A417 Missing Link

Cotswolds Conservation Board - Options Report

HE551505-ARP-HGN-X_XX_XXXX_X-RP-C-000005

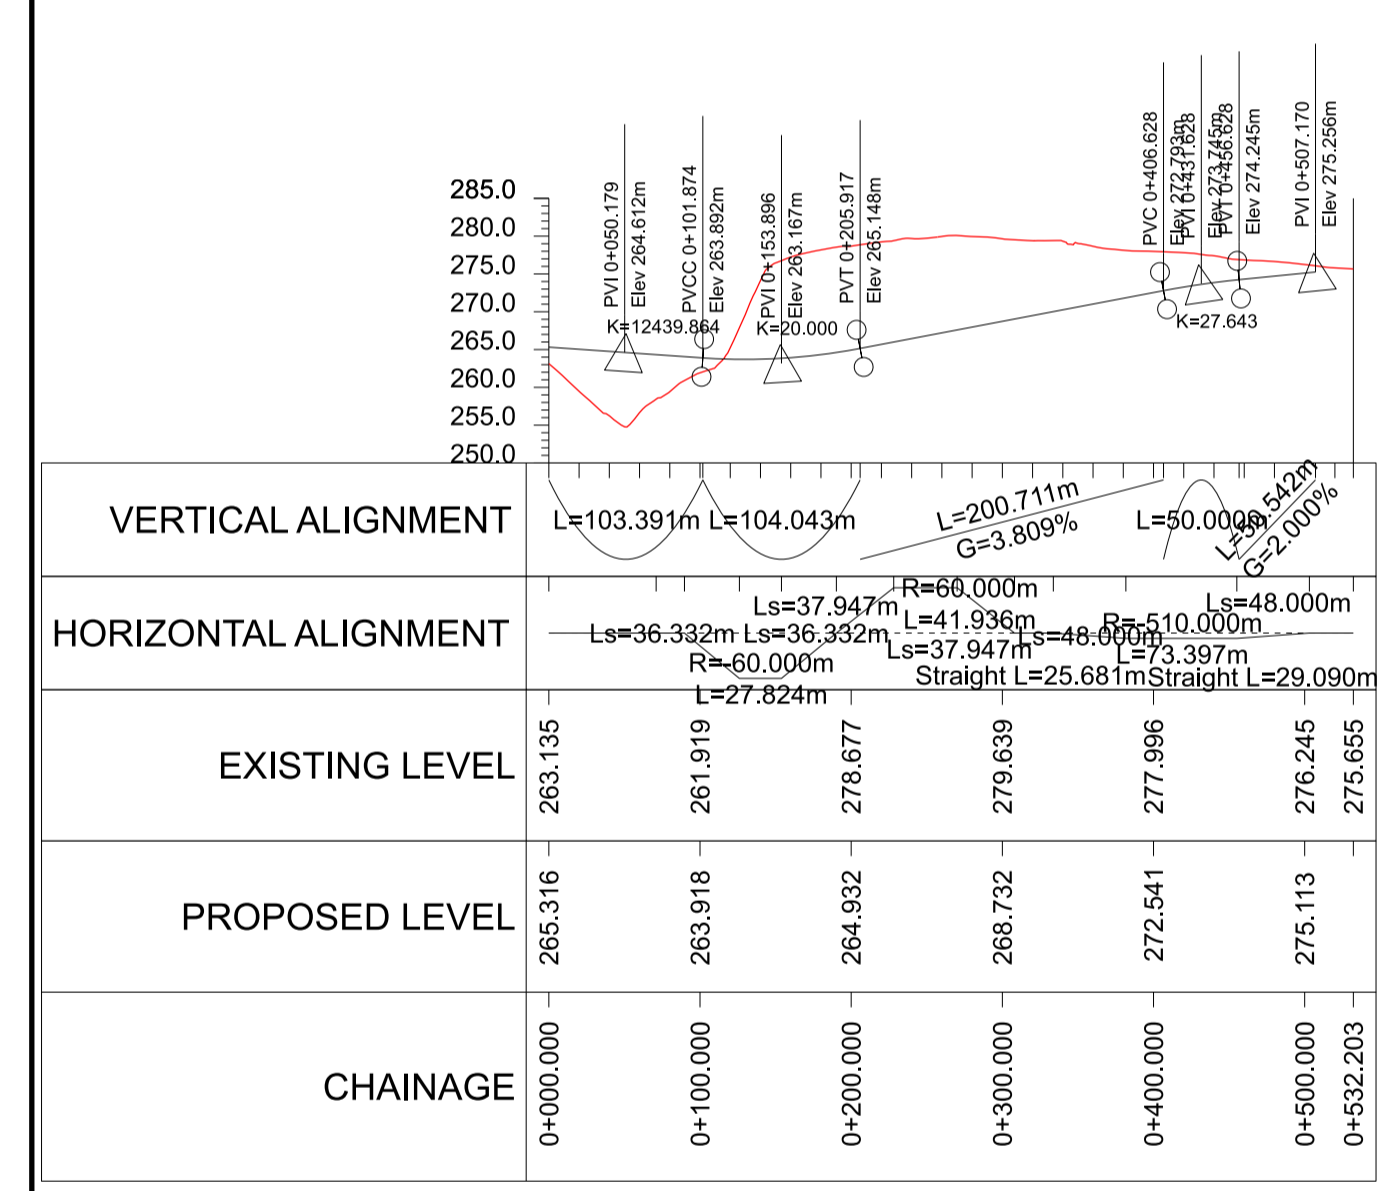
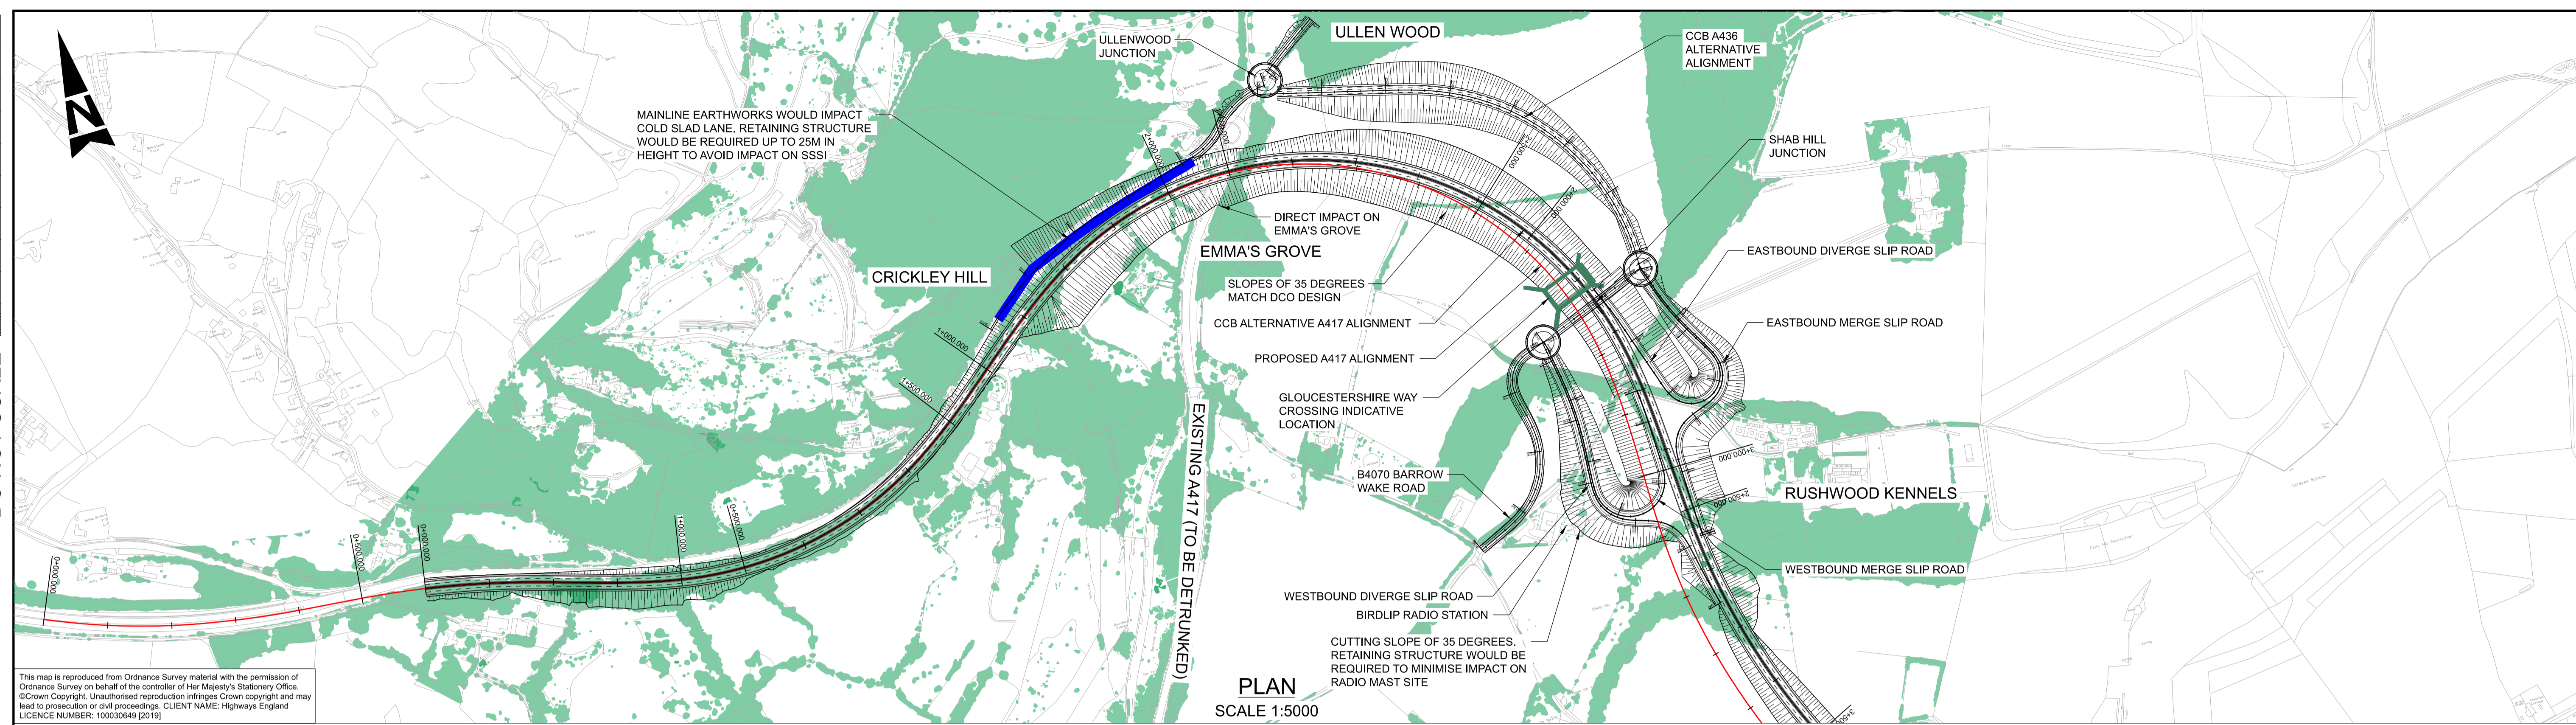
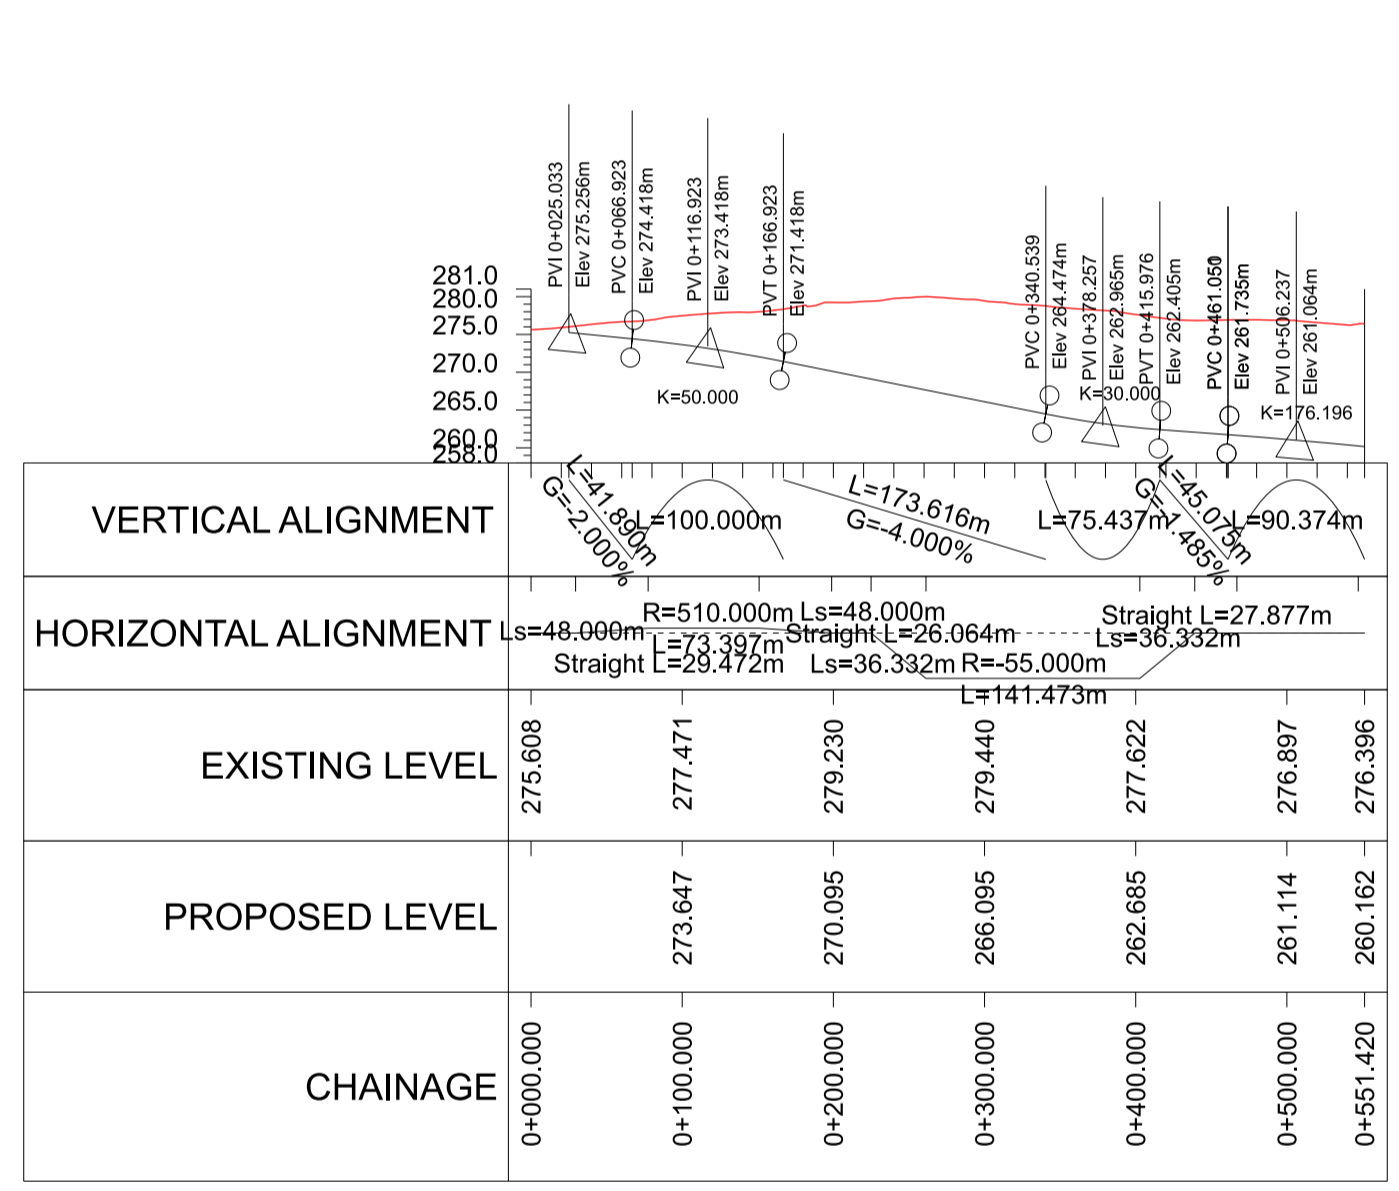
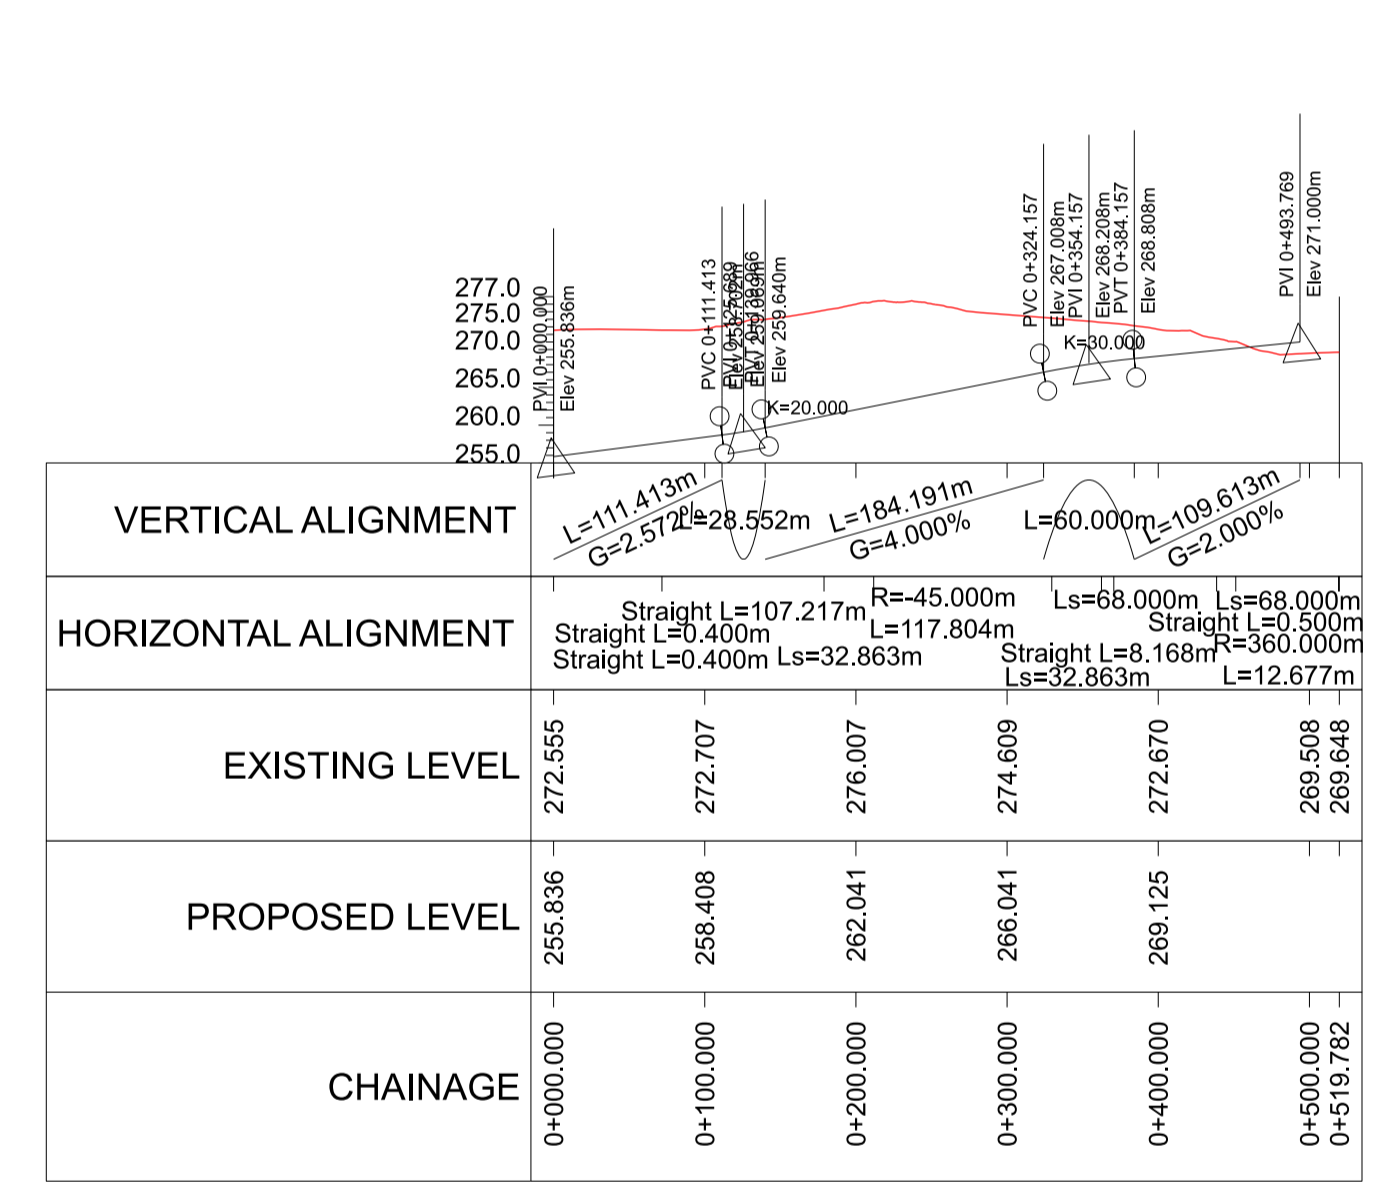
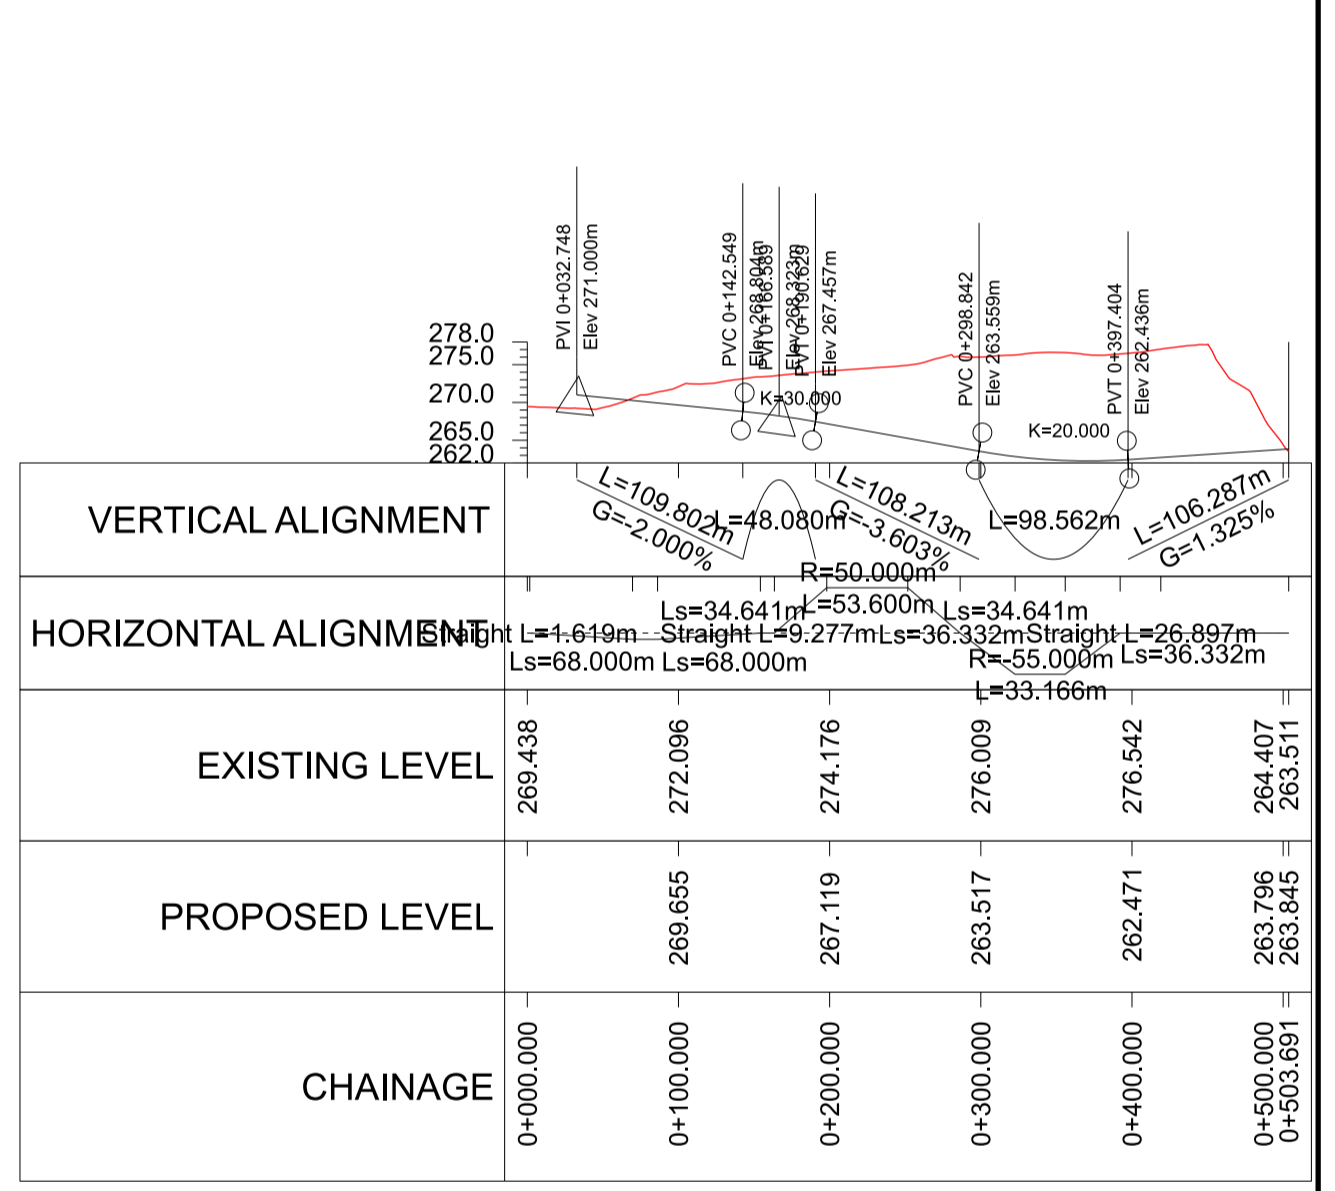
- 6.4.3 The plan/profile drawings HE551505-X_XX_XXXX_X-SK-C-000097 and 000098 in Appendix C, demonstrate the layout when designed in compliance with current highways design standards.
